# XSPI Adapter Pin Change

## Memo

May 2005

Figure 1: XSPI Adapter Current Model (Pin 24 Ground)

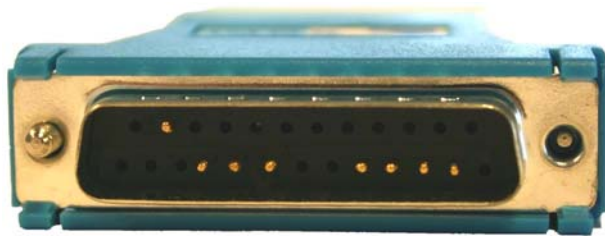
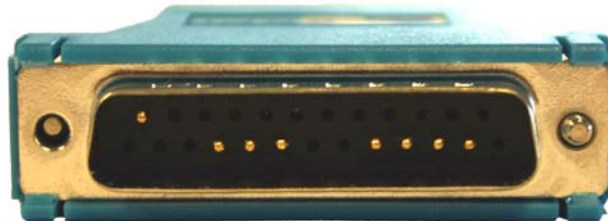
Some laptop PCs do not have Pin 25 of the printer (parallel) port connected to ground. This means that the CSR XSPI adapter will not work with these PCs.

XSPI adapters are now manufactured by CSR with Pin 24 connected to ground. From now on, this configuration will ship under the existing stock code.

Other than this pin change, the adapter is identical to the original. To tell the difference between models, check the pin-end of the adapter and note whether the top left pin is 24 or 25.
